McLaren 750S Spider - Door Sensor Reseal and Door Control Unit Inspection

Bulletin type:	Service Campaign
Reference number:	N/A
Campaign reference:	SCB 28 A 001
Attention:	Retailer Aftersales Managers, Retailer Service Managers, Retailer Service Advisors, Retailer Technicians, Retailer Parts Managers
Affected vehicles:	McLaren 750S Spider
Situation:	Resealing of the door sensor and inspection of the door control unit
Procedure:	Action affected vehicles on first opportunity (immediately if already on site or during next Retailer visit if not already on site). Please refer to the information outlined in this document to complete the required work
Date:	23 August 2024

Image 1 Rework and Inspection Area

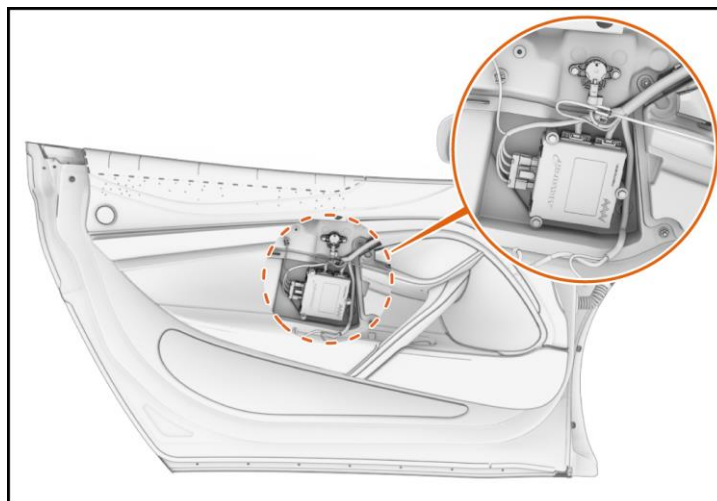
Through continuous product quality monitoring, McLaren Automotive has identified that on certain McLaren 750S Spider vehicles, the internal door panel to the peripheral pressure sensor housing interface requires resealing in the area behind the door card. In the same area behind the door card, the door control unit requires inspection for contamination.

To inspect the door control unit, follow ‘P28 Spider Door Sensor Reseal and Door Control Unit Inspection’ work instruction attached with this Service Campaign bulletin. To perform the required work to reseal the door sensor housing to the door inner, follow McLaren Service Portal (MSP) D051050 ‘Occupant Restraint Control (ORC) Peripheral Pressure Sensor’ work instruction.
